# NWRL EIS 1 SUBMISSION

BY THE GPT GROUP

May  
2012

### 4.0 Programme

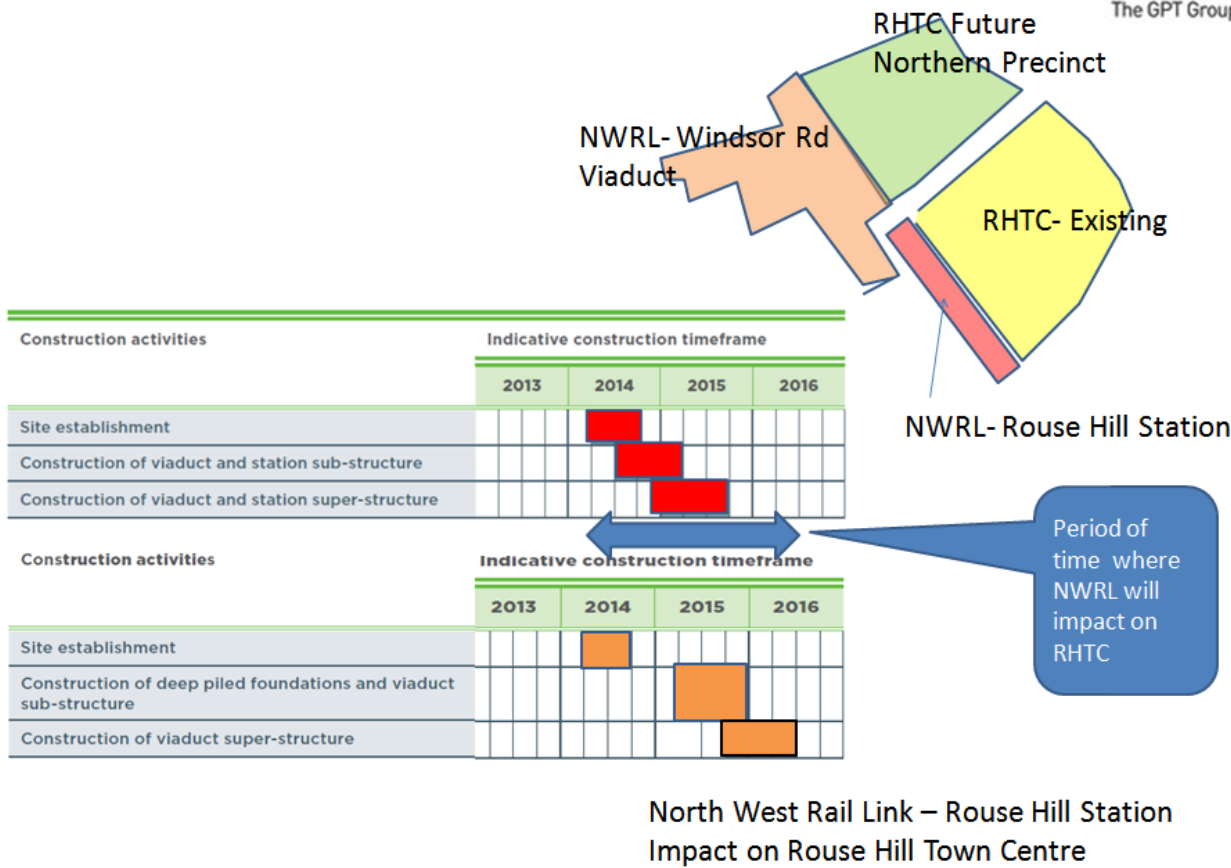
The programme for the NWRL works affecting RHTC are currently scheduled to extend from March 2014 to July 2016 (28 months)

It is possible that this scope could take up to 36 months in reality and the time frames could also shift for many reasons including approval processes etc.

- Programme; The lack of detail and coordination of the works from station to station warrants the NWRL to put together a sequential programme showing the progressive completion of all the works at the varying completion dates in order that the stakeholders can assess the real impact on their developments.

Old Windsor Road to White Hart Drive site layout

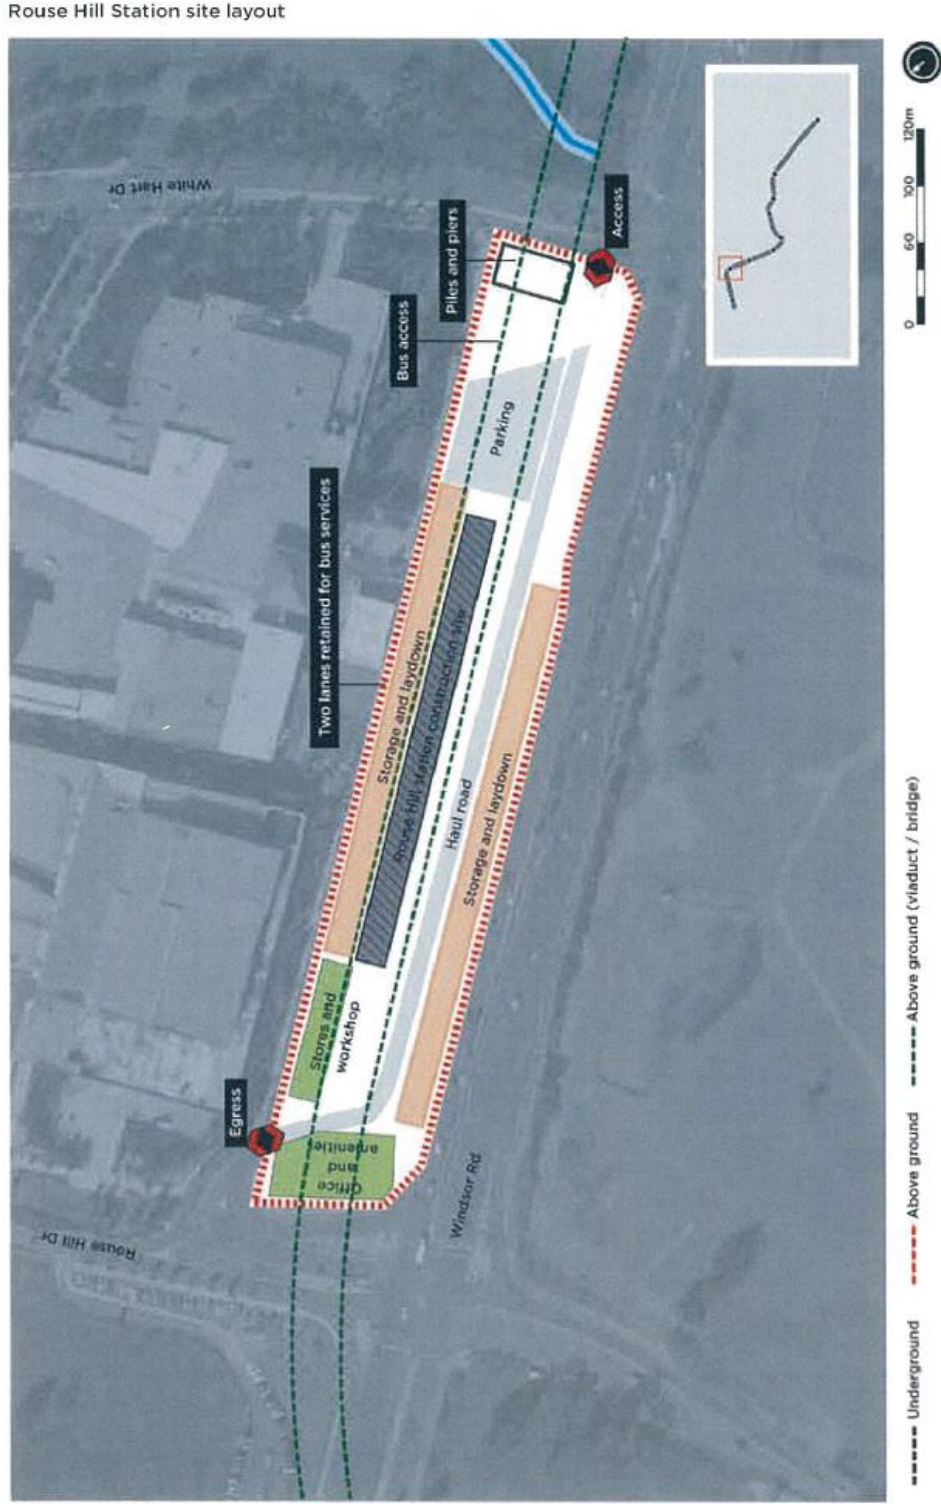
- The site layout showing all elements such as hoardings ( A or B class ) sheds e.g. ablutions, lunch and change sheds, site offices and entry and exit gates, temporary electrical, and hydraulic services, craneage, must all be detailed and issued to RHTC for review and approval

- The Principal Contractor to issue for approval by RHTC a detailed 1:100 scale site plan showing location of all the elements that will be contained within the compound prior to commencement.
